SEWAGE DISPOSAL SYSTEM

SUBDIVISION West Friendship Estates LOT 41 ROAD 3121 Fox Valley Drive

B00104650
 West Friendship Estates
 Lot 41
 For Deck Address
 (A49023)

Approved Septic System Plan
 FENWICK MODEL Howard County Health Department
 HAMILTON REED HOMES

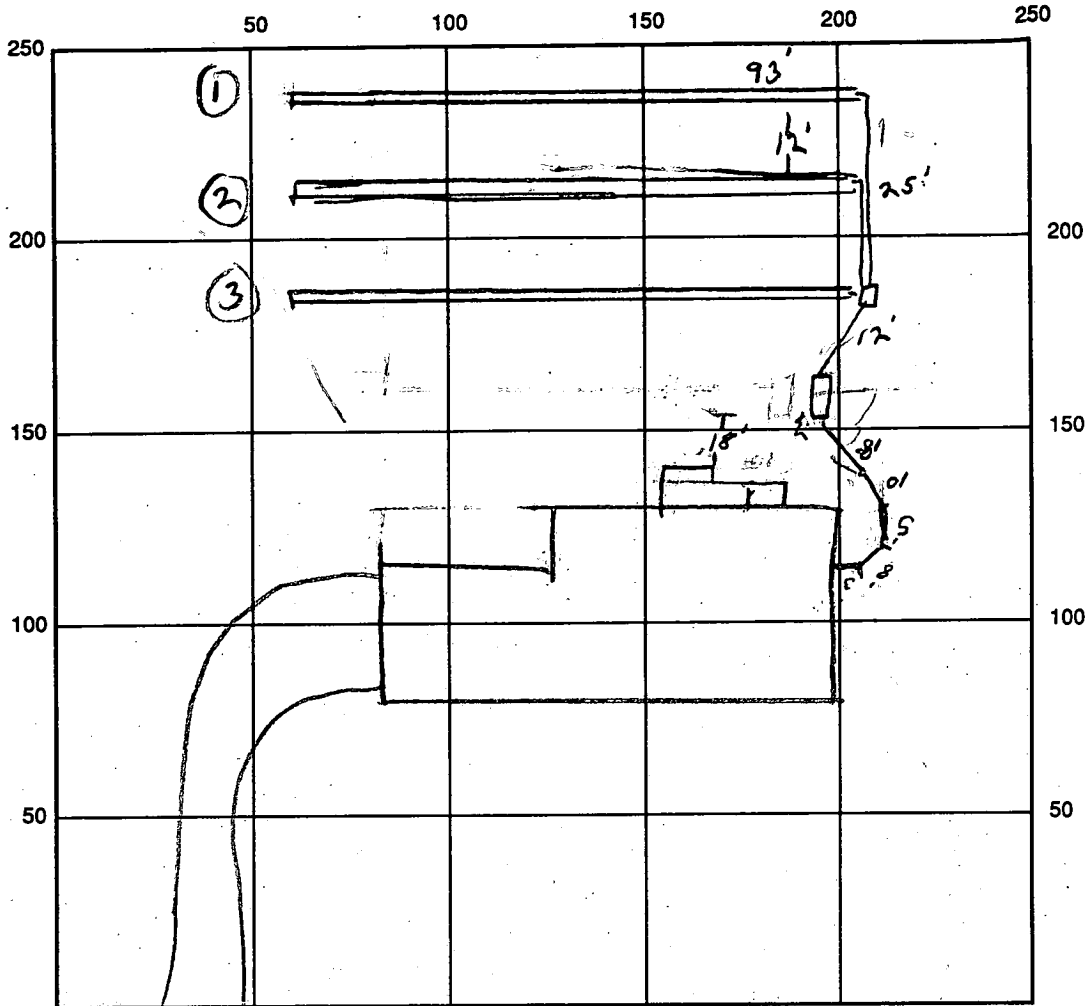
REMARKS: 5-15-96 TRENCH 3 NOT COMPLETE, DIST BOX NOT CONNECTED
RAIN EXPECTED, CONTRACTOR IS FINISHING JOB TODAY OK TO COVER IF
IM UNABLE TO RETURN BEFORE SYSTEM IS READY TO COVER. SOME
GOOD - NO RICK. 88

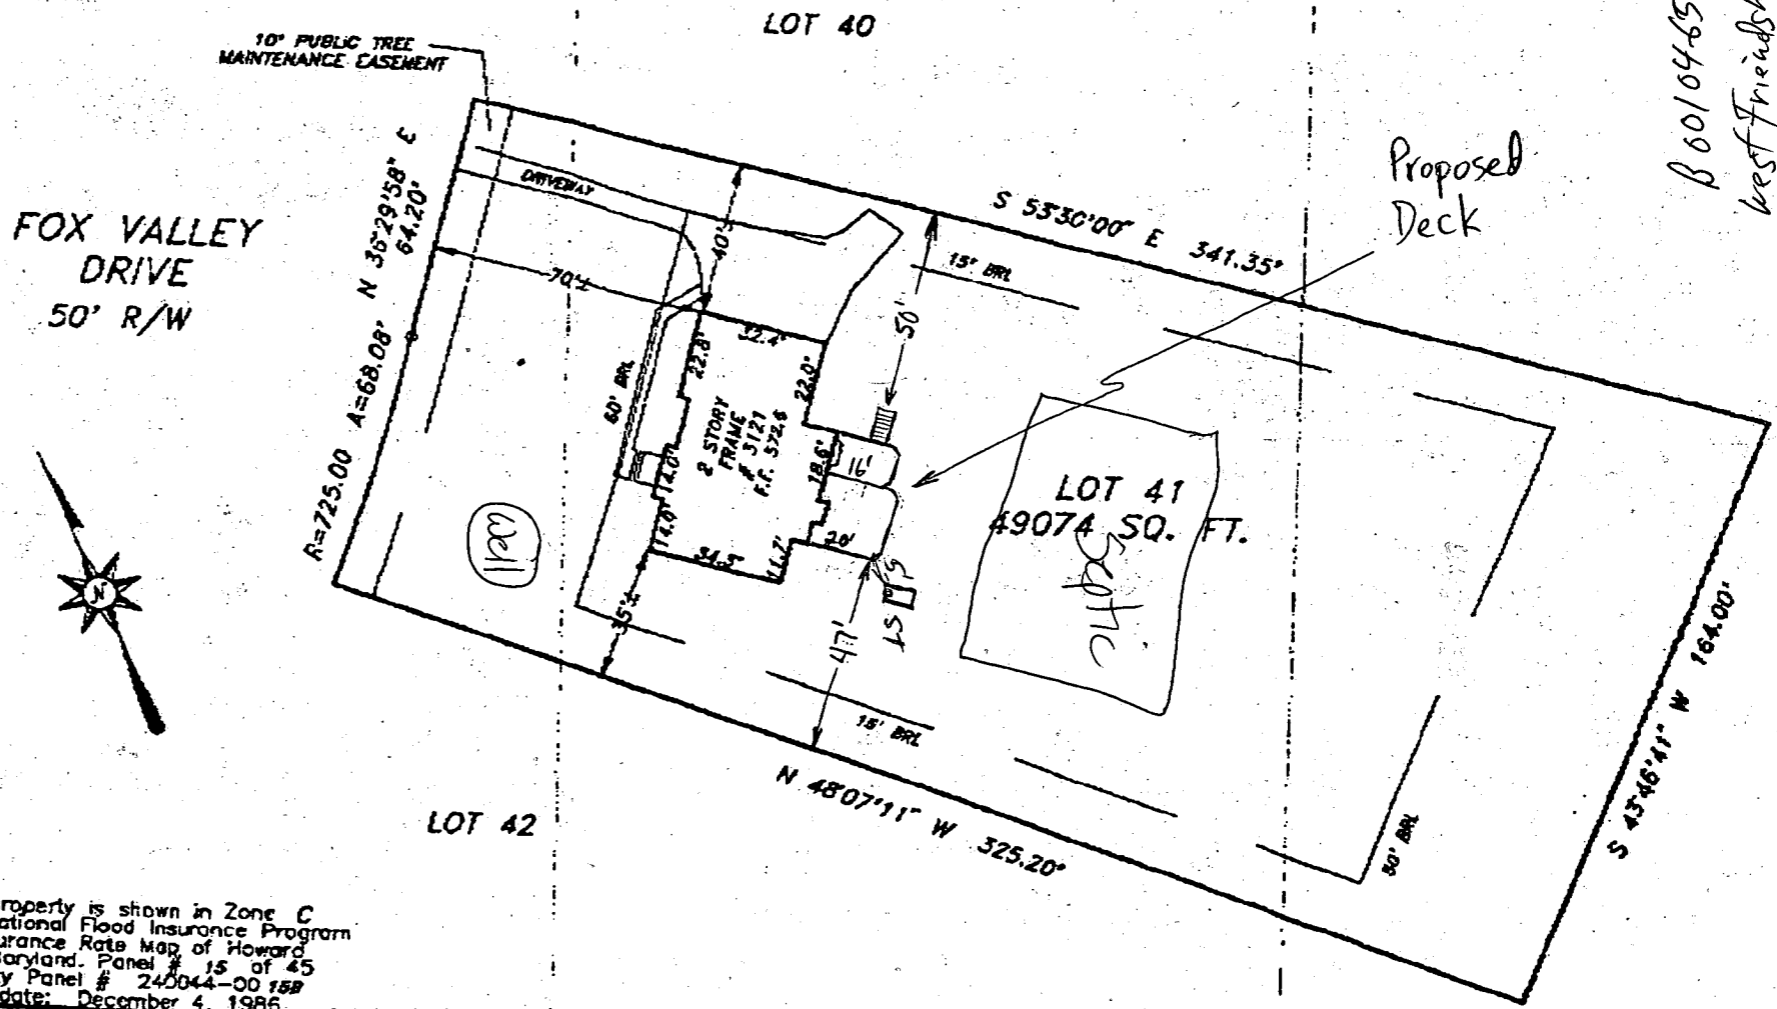
WALK THRU
 PROCESS
 NOT COMPLETED
 WILL RETURN
 WITH REVISION
 TO PROVIDE
 2 - ADDITIONAL
 CLEANOUTS TO
 OPTIC TRACK
 THRU OK
 4/24/14
 CW

PLEASE NOTE:
 The deck floor
 at this point
 will be approx.
 ten feet above
 the ground.

20' 6"
 Above to Cleanout

LOCATION DRAWING
3121 FOX VALLEY DRIVE
WEST FRIENDSHIP ESTATES
3RD ELECTION DISTRICT
HOWARD COUNTY, MARYLAND

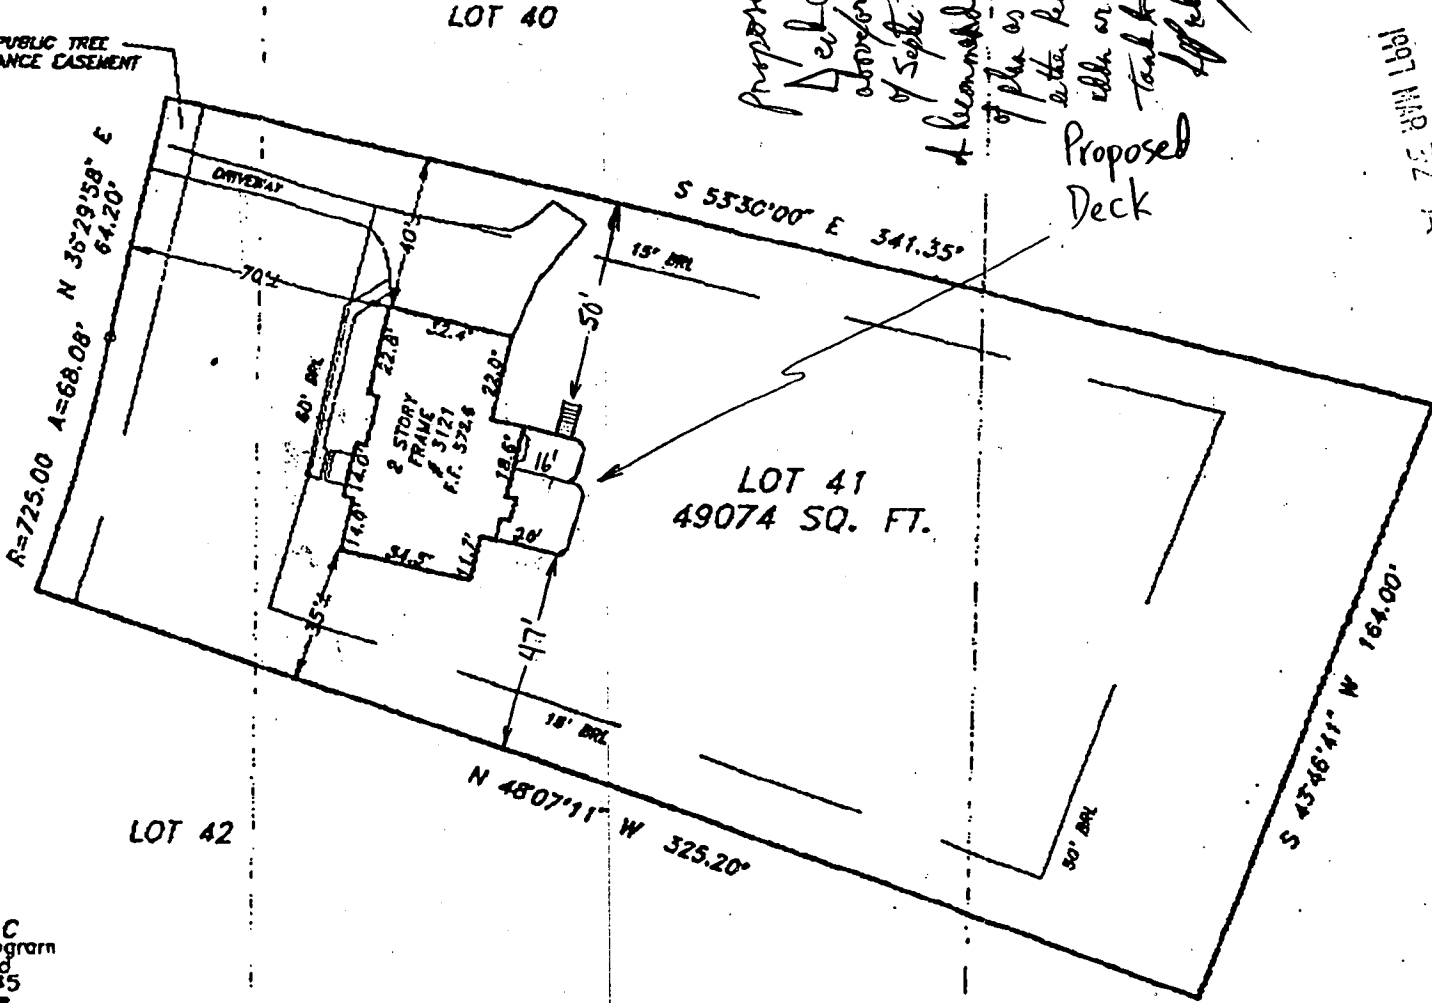
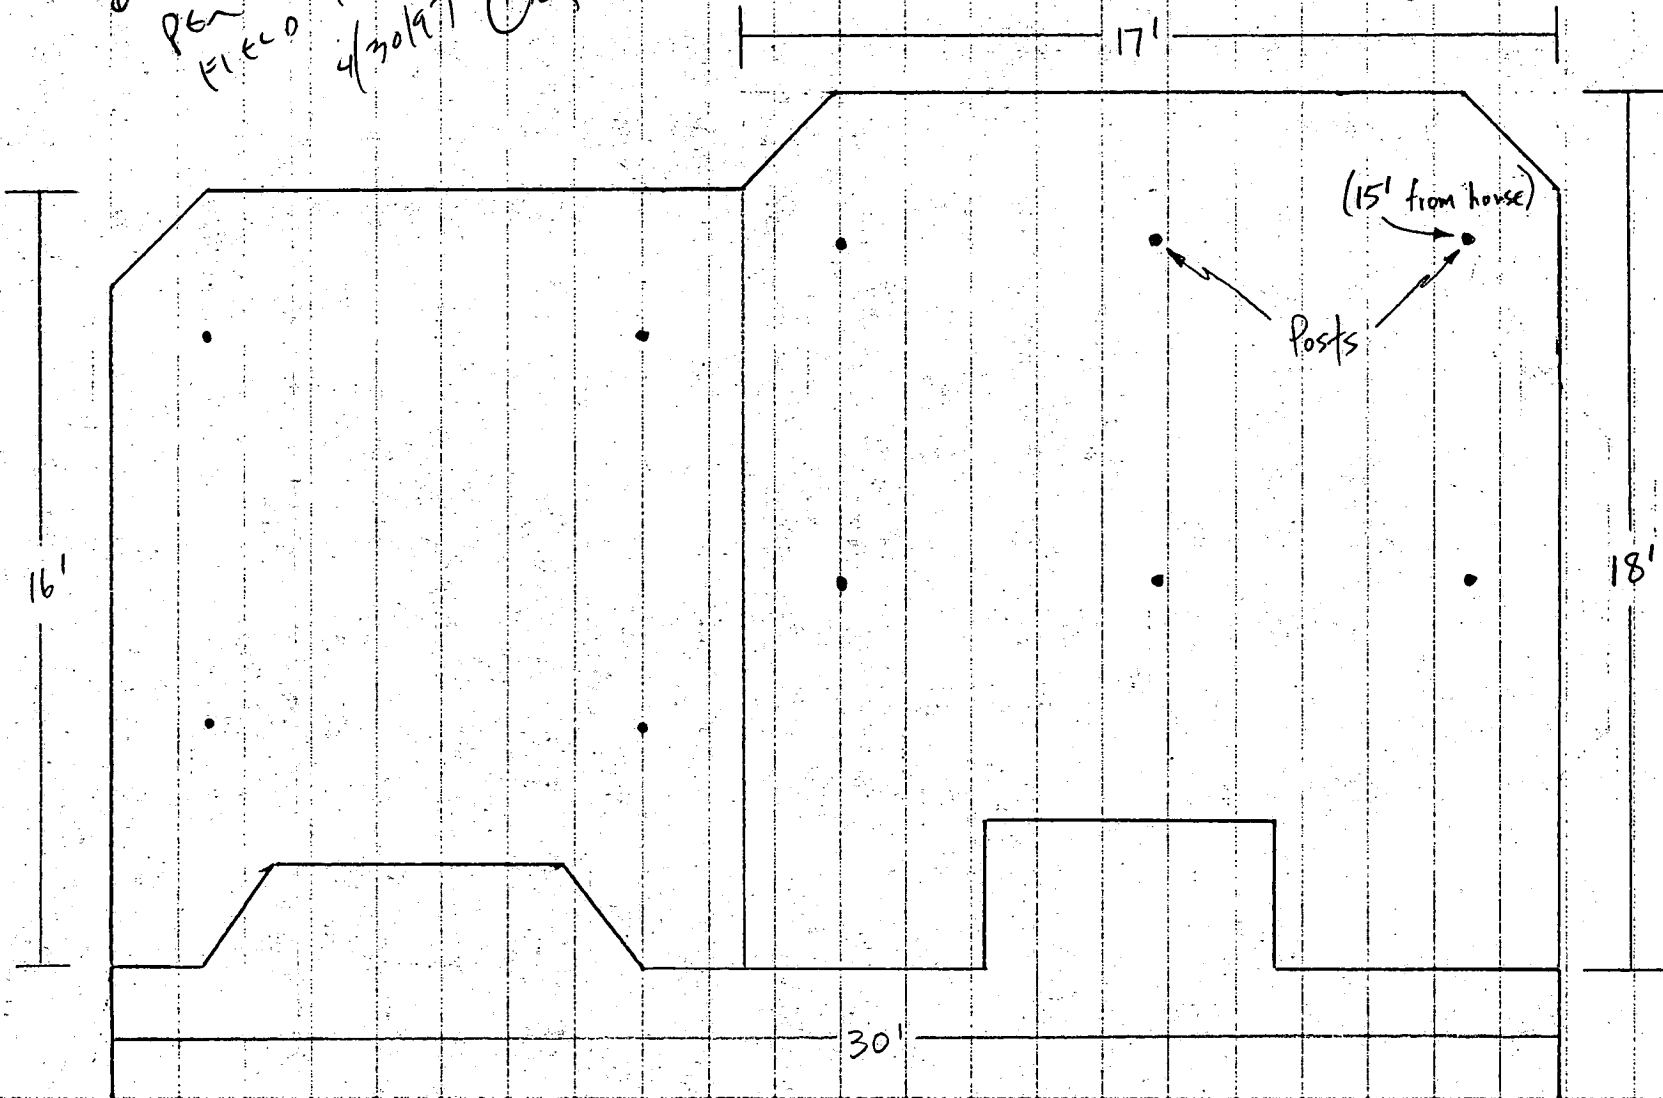
*Proposed Deck
Deck overhang in
approx. 18" width of
Sept. Tank wall,
it be removed. Disapproval
of plan as shown. Support
either perpendicular
with or above Sept.
Tank to 10 ft depth.
Eff. July 4/1997*
